Public Hearing for NorthWestern Energy Floodplain Variance Request (FA-06-11)

REQUEST FOR COMMISSION ACTION

OG-06-08-984

1. Project Name Missoula-Hamilton 69kV Transmission Line

NorthWestern Energy Floodplain Variance FA-06-11

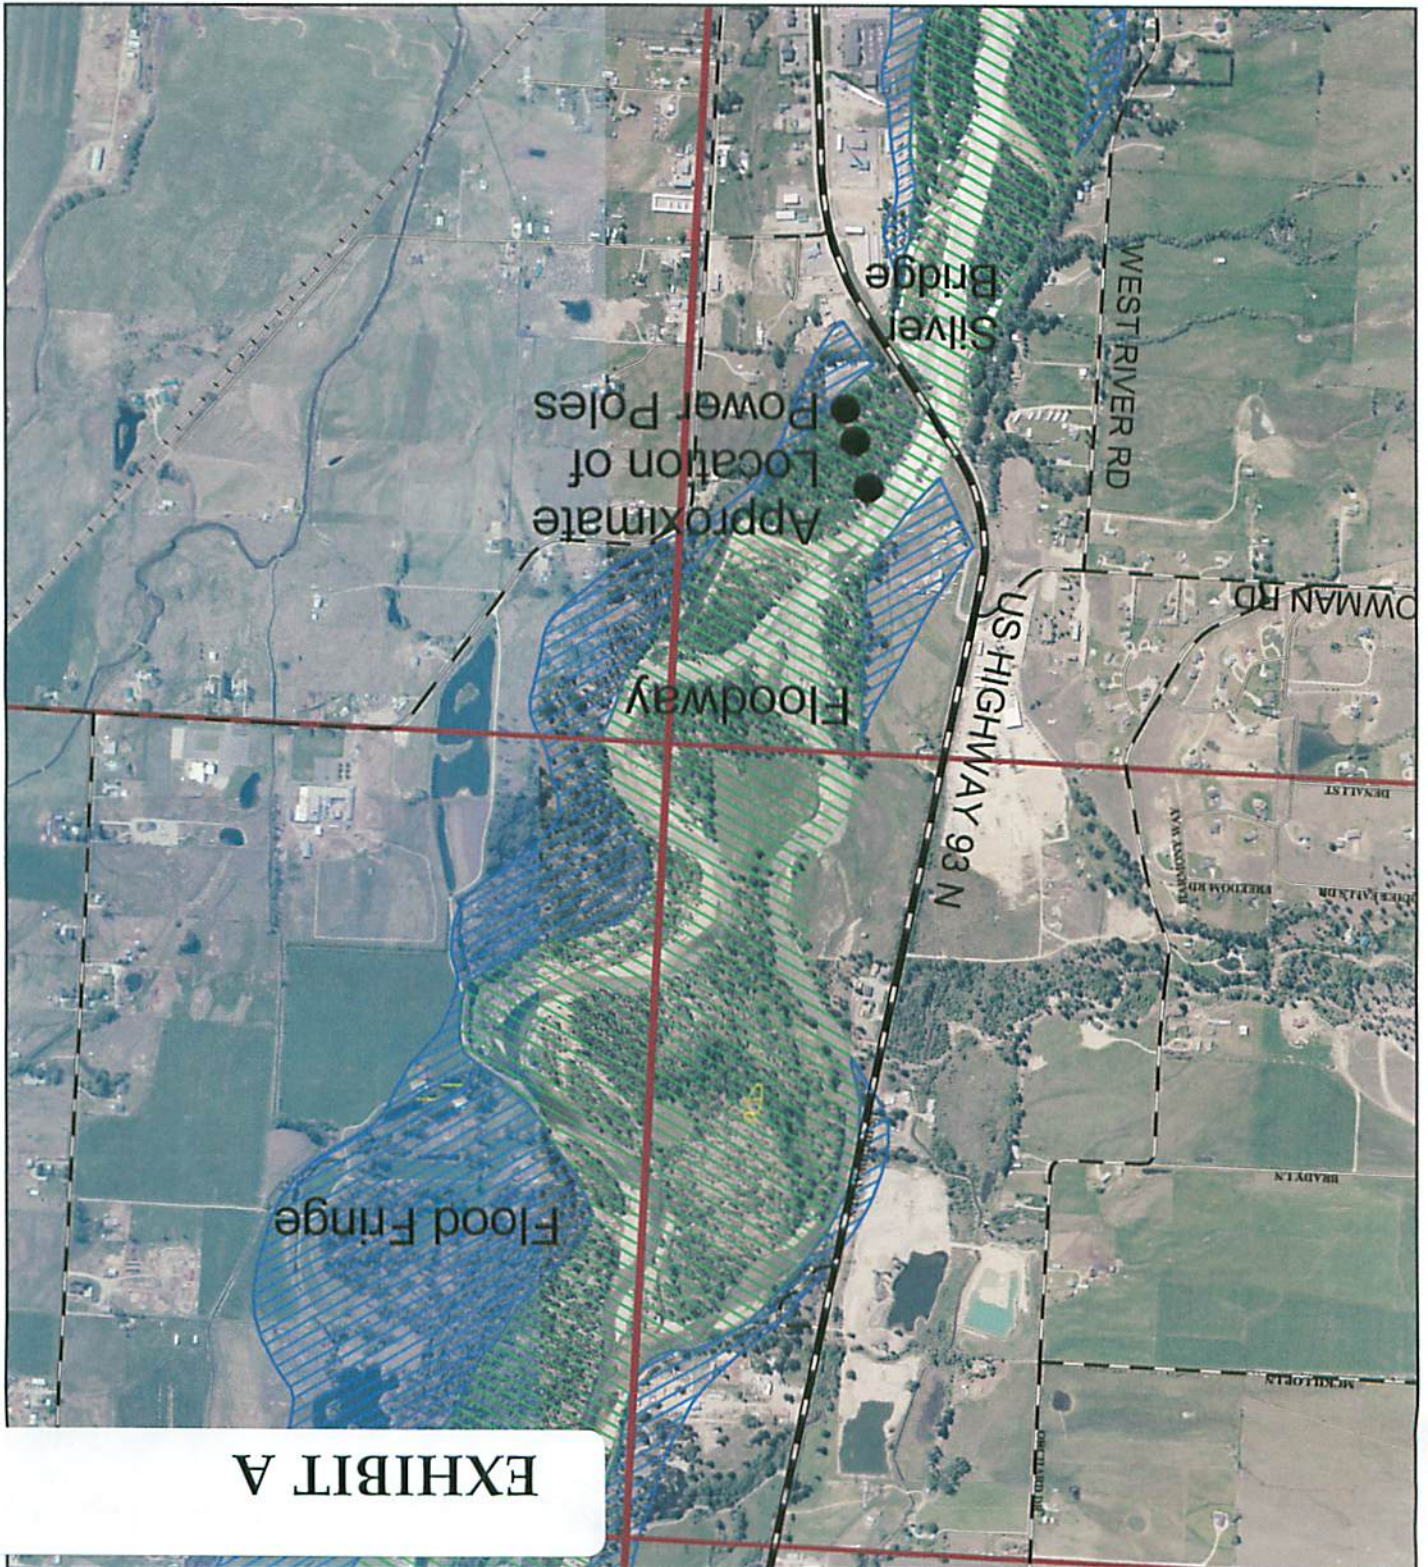
Laura Hendrix presented that the Floodplain Variance Request was to locate 3 power pole transmission structures in the floodway portion of the 100-year floodplain, an action that varies from the development standards in the Floodplain Regulations. Staff recommended that the installation of the 3 power pole transmission lines in the floodway be approved based on the positive findings of fact for each of the variance review criteria.

This application looks pretty good. The poles shouldn't have much of an impact, if any, since the highway is between the river and poles 0-27 thru 0-29, and poles 0-4 thru 0-15 are in the hydraulic shadow of the bridge and approach fill. This includes the poles that will utilize the special CMP structures.

I am however a little concerned about pole 0-9. It is located on the bank of the outside bend in the river in an area very close to outlet of the bridge opening. This is a transitional area from a flow regime standpoint because of the bridge and the outside bend of a river is an area the usually sees the highest erosive forces of the flows. Therefore, this could make pole 0-9 very susceptible to being undercut or washed out by bank erosion. I would hate to see the pole lost to erosion or the power company have to come back in a year or two and need to apply for rip rap in order to protect that pole.

I would recommend that the possible erosion of pole 0-9 be discussed with Northwestern's engineer, and if they do not feel that there is any concerns, a letter from Northwestern stating that (along with a PE stamp) should be put into the file.

Commissioner Thompson motioned that the variance request from the Ravalli County Floodplain Regulations, Chapter 4, Table 4-6-1 for the proposed installation of the 3 power pole transmission lines in the floodway portion of the 100-year floodplain be **approved** based on the positive findings of fact for each of the variance review criteria as noted in the staff report.
